Docket Item # 3 & 4
BAR CASE # 2015-0189 & 190

BAR Meeting
July 1, 2015

ISSUE: New Construction: Buildings 1 and 2

LOCATION: 2 Duke Street

BLDG 01 - ENLARGED WEST ELEVATION

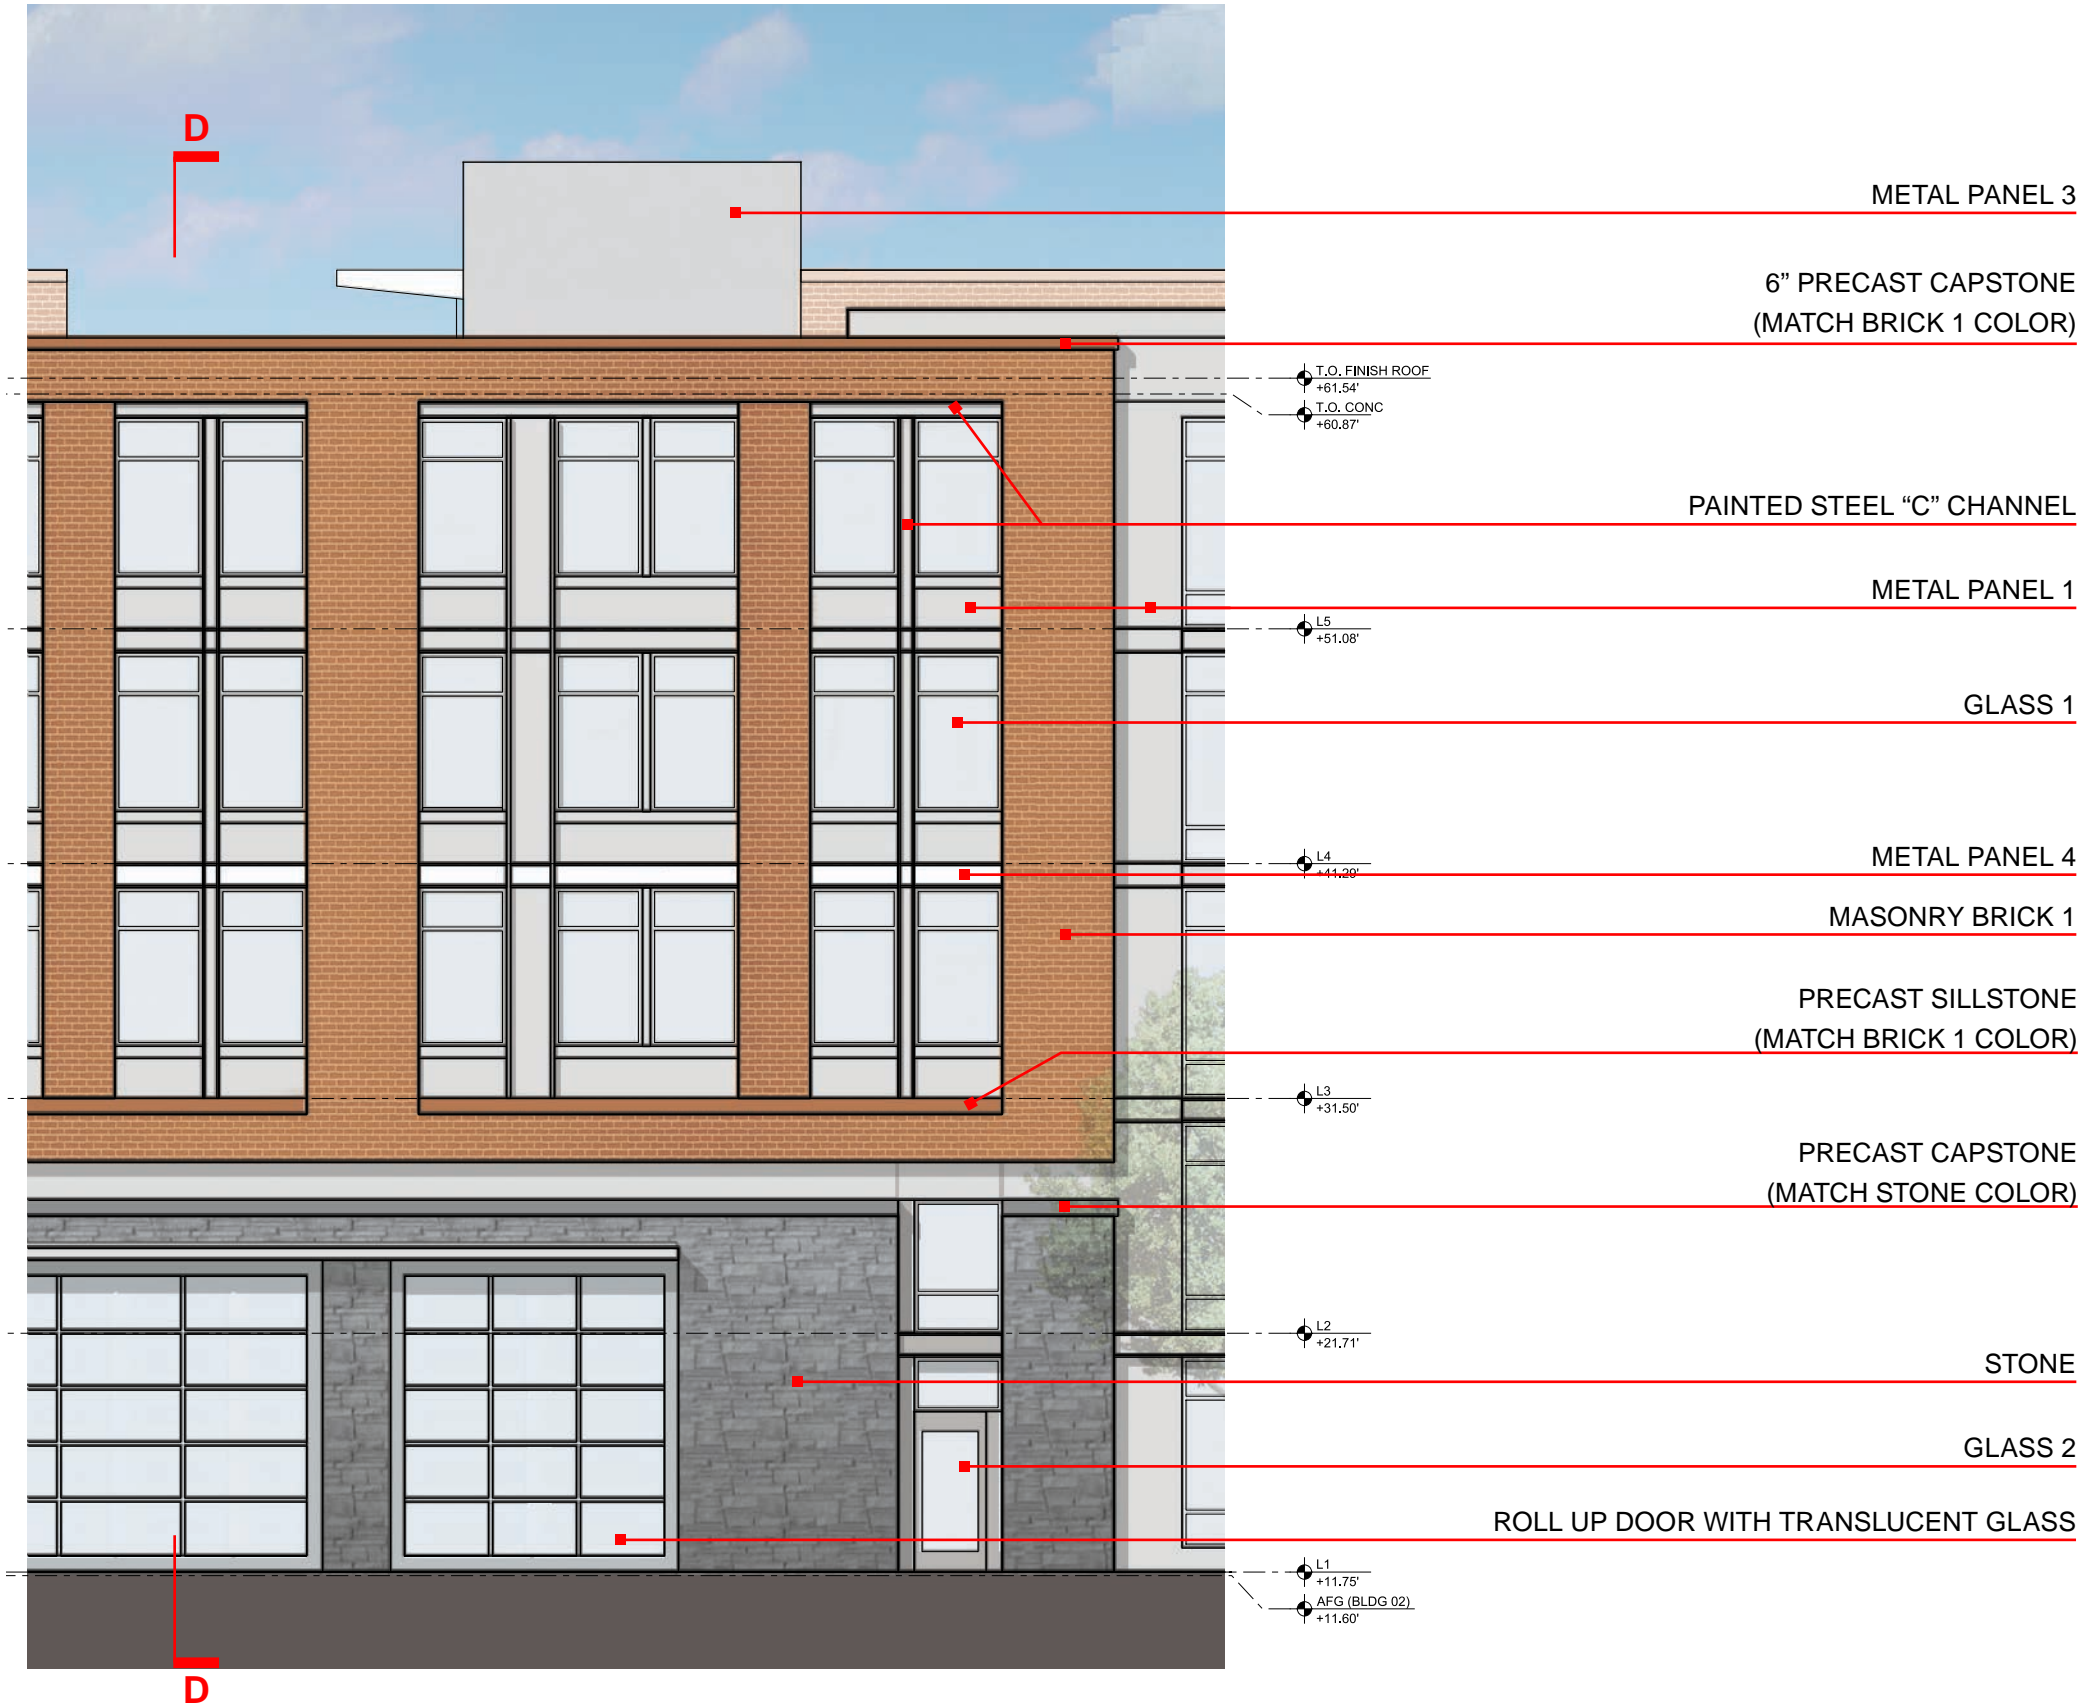
- c. Select a stone lighter in color and with a more random rustic rubble configuration, similar to that at Fitzgerald’s Warehouse.
 - d. Remove the awnings above the garage doors and recess the garage and loading doors.

Figure 2. West elevation of Building 1 showing stone base, garage/loading doors and applied brickwork.

Building 1 is a building without a “back” as the west elevation is on The Strand and will be a significant walking street despite the locating of the garage entry and loading dock on this elevation. Staff recommends a clean approach to this area and advises removal of the small canopies and the use of translucent doors within a more pronounced recess to reflect that these are large openings within a masonry wall.

BLDG 02 - ENLARGED SOUTH ELEVATION

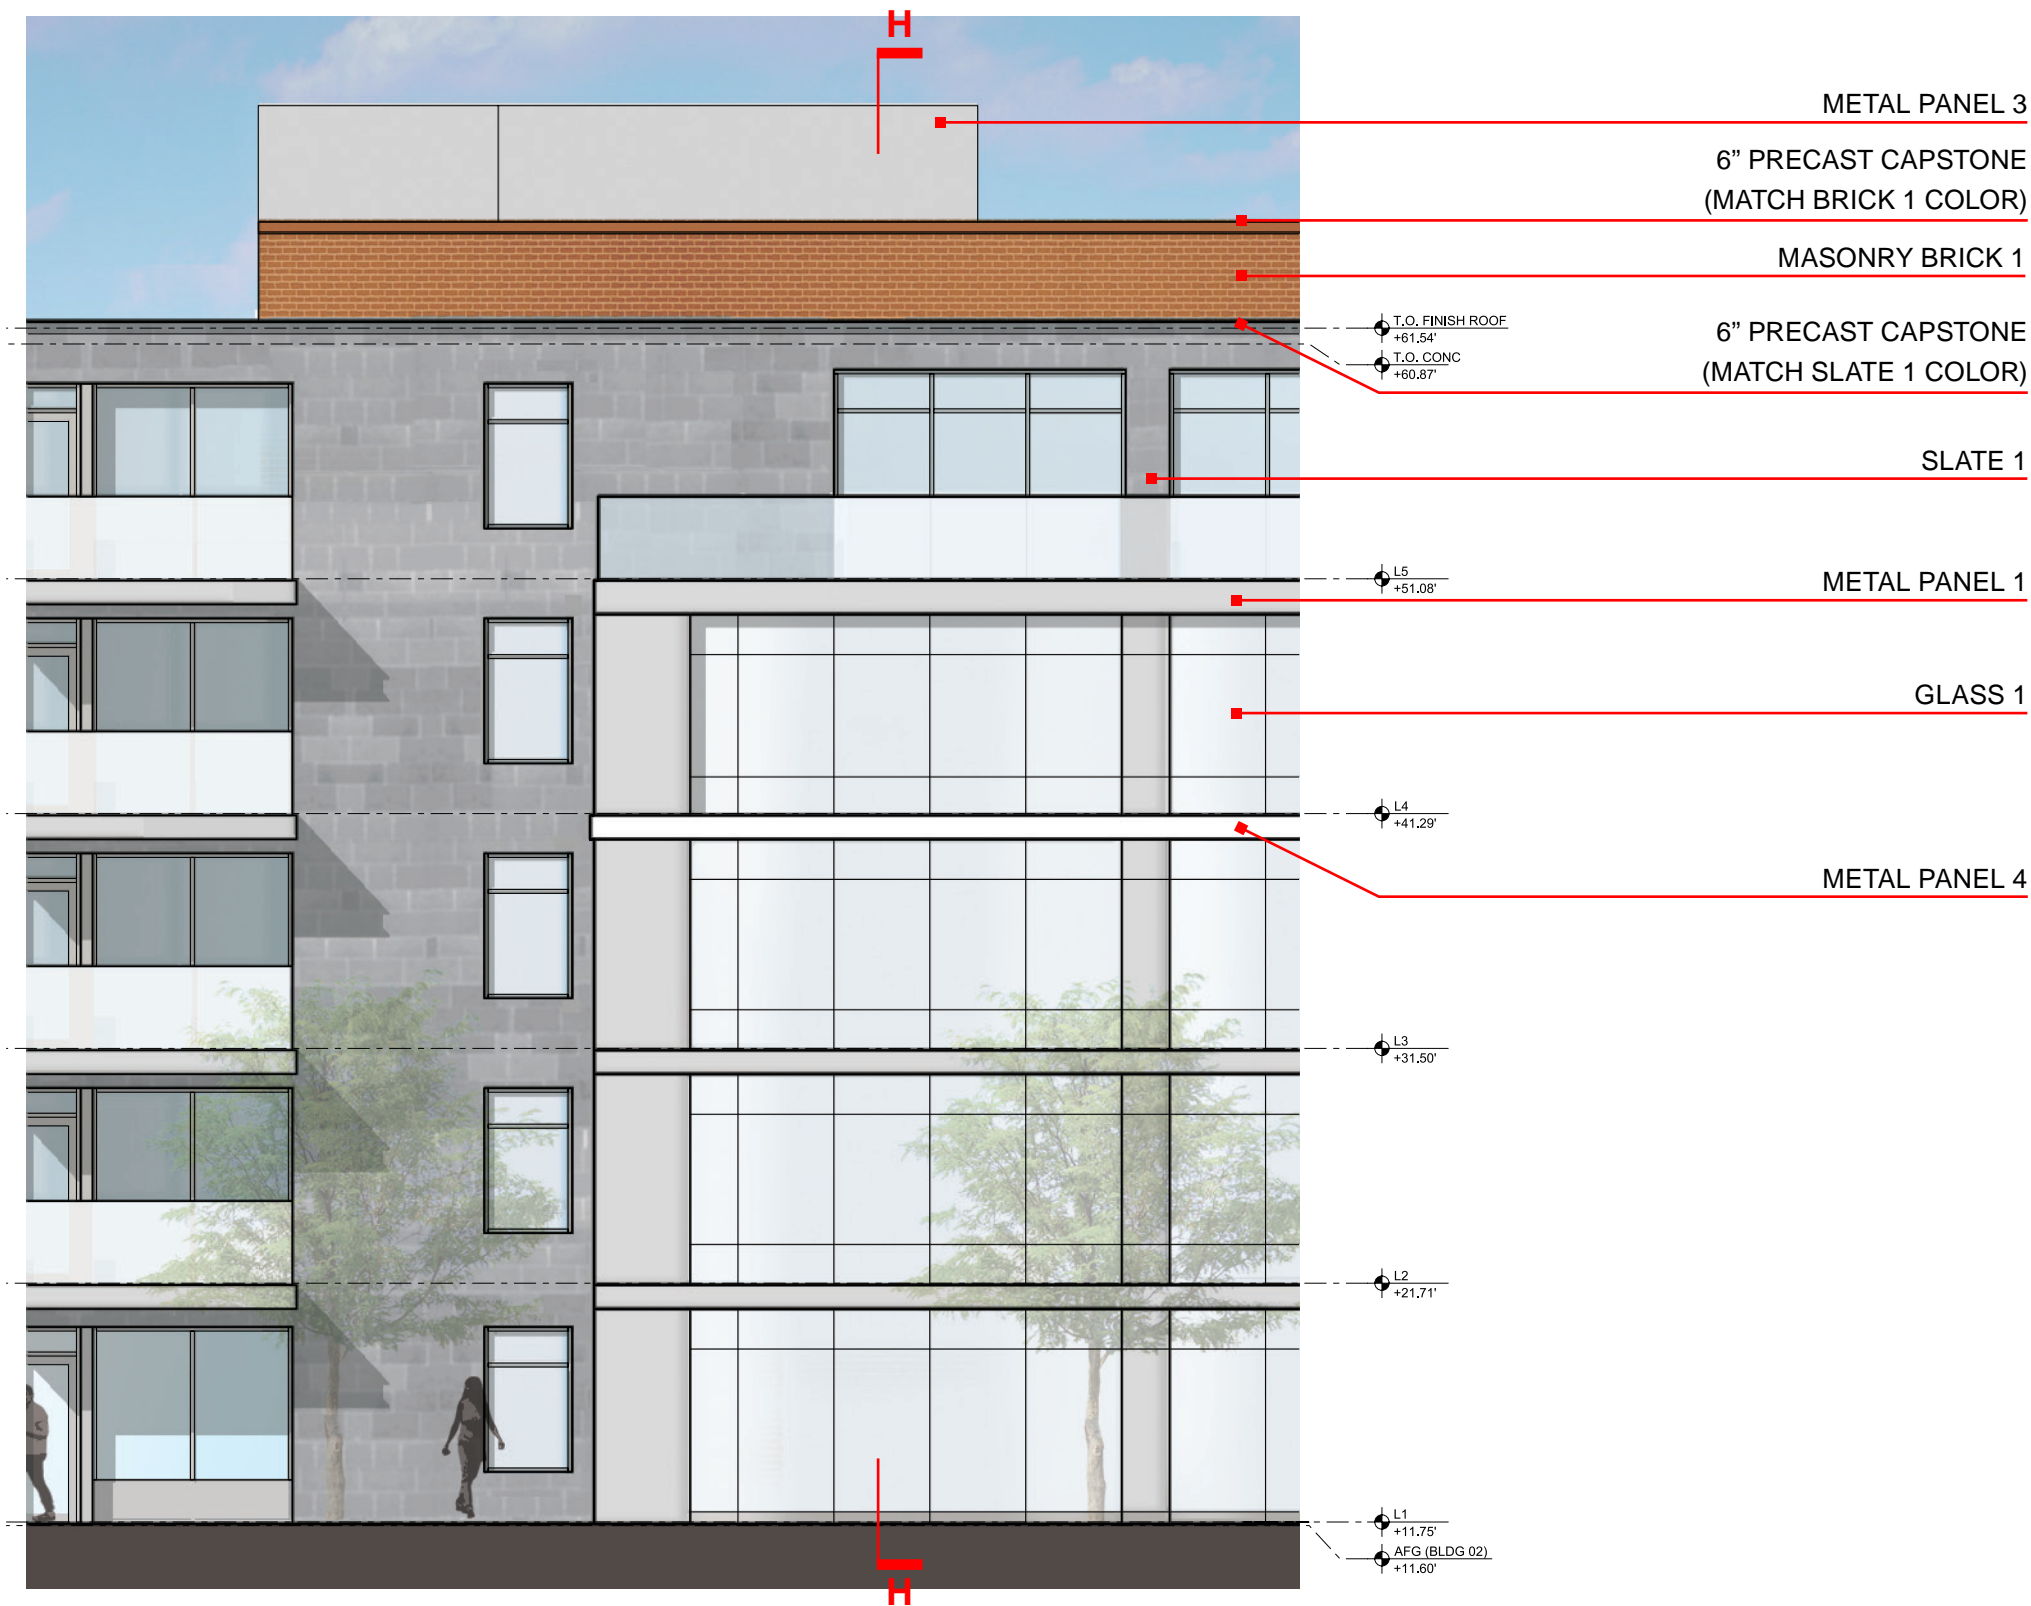
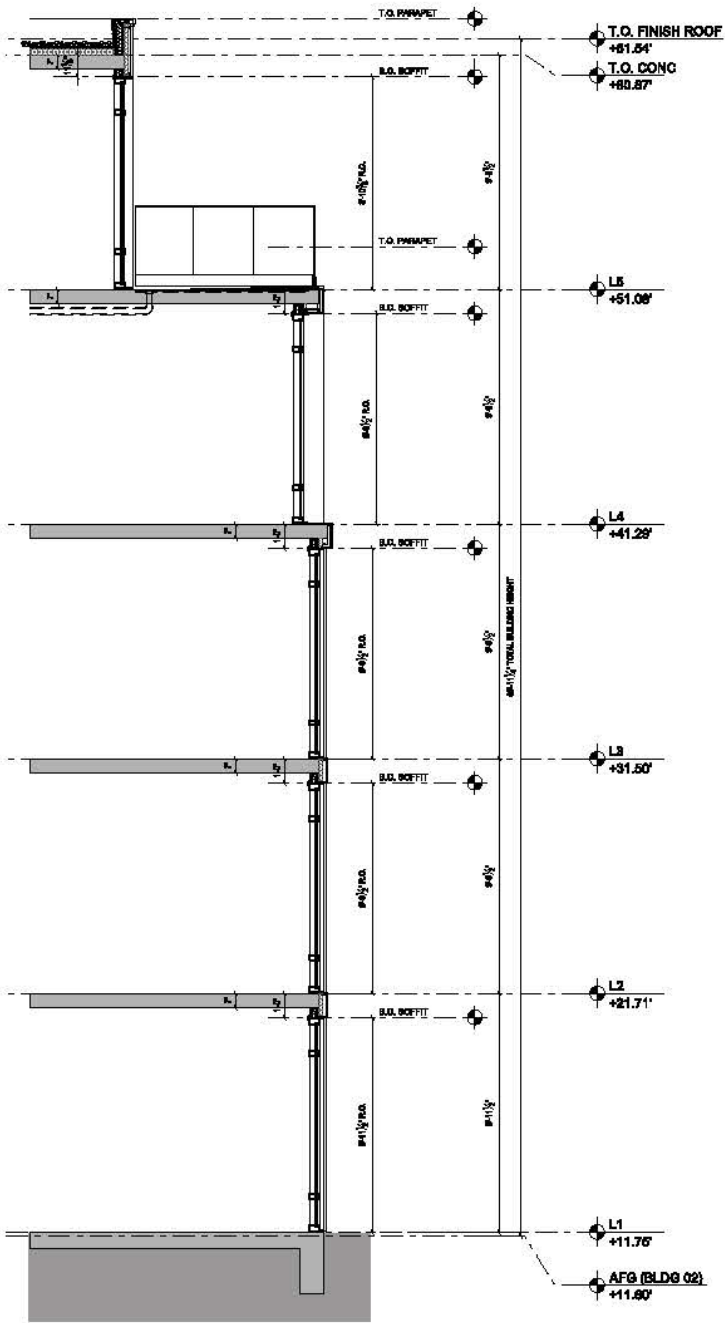
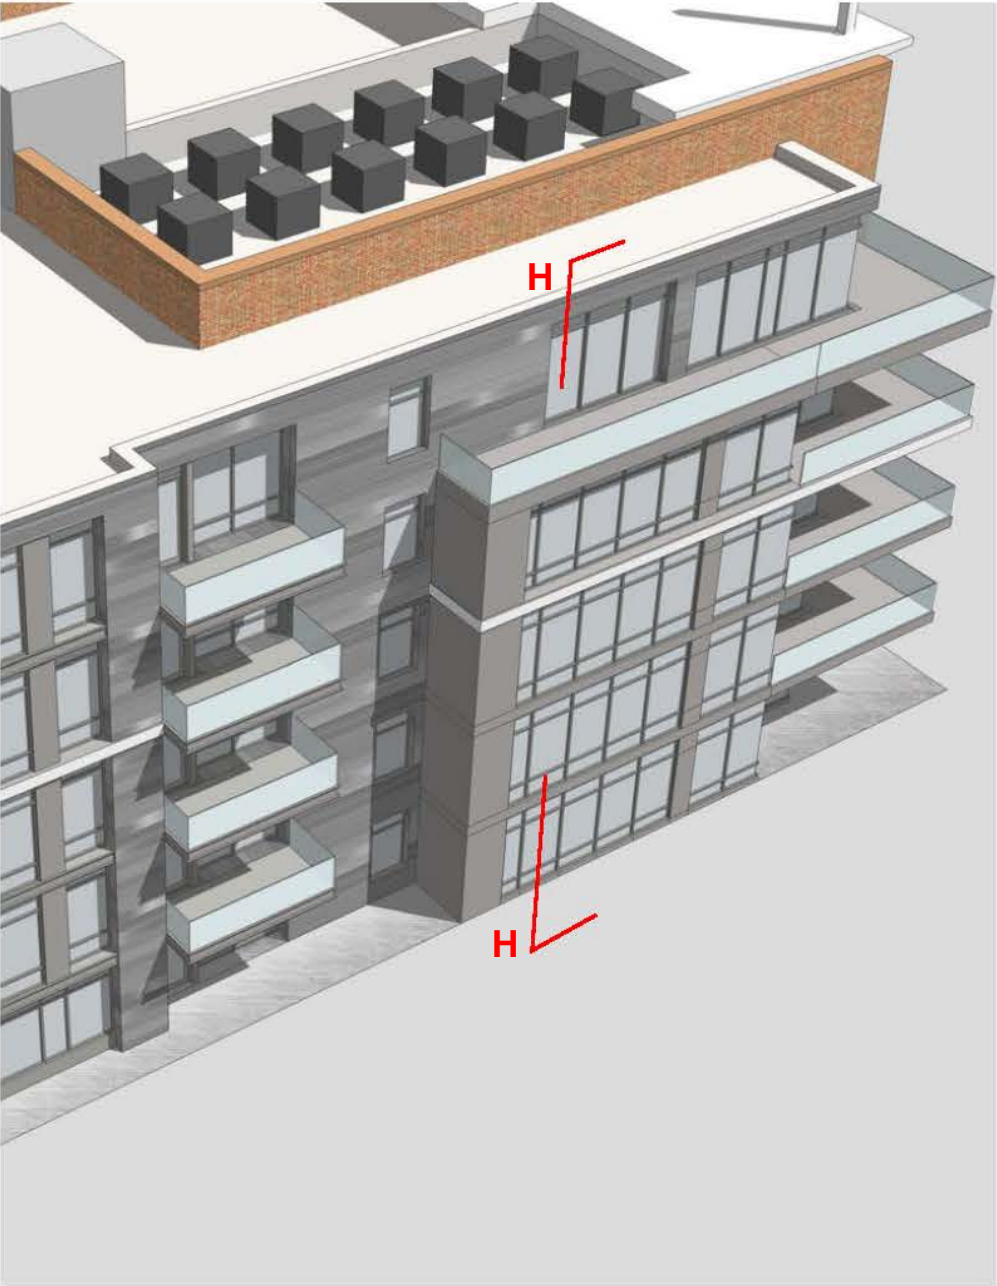
6. At Building 2:
 - a. Add brickwork and sunscreens to the south elevation to better relate to other elevations.
 - b. No residential doors are permitted at the first floor on the waterfront elevation.

In general, Building 2 is quite successful and the applicant should continue in this design direction. While the rear elevation, which features substantially more brick than the other three elevations, may appear repetitive, staff notes that it will only be visible in relatively small segments through the various alleys and paths and will have meaningful streetscape improvements including street trees. However, the south elevation of this building needs further refinement. Staff notes that it is the only elevation of the two waterfront buildings without any brick. While not the sole cause, the lack of brick here does contribute to a stark appearance to this elevation. Therefore, in keeping with the other patterns of how brick is used on these two buildings, staff recommends that the wall immediately to the east of the central balconies be brick. Additionally, to soften this elevation and relate the residential character of this part of the building, a solid sunshade should be considered at the fifth story that would wrap around slightly to the waterfront. The addition of this element would further distinguish Building 2 from Building 1 while adding an interesting architectural feature.

Figure 3. Perspective rendering showing south elevation of Building 2.
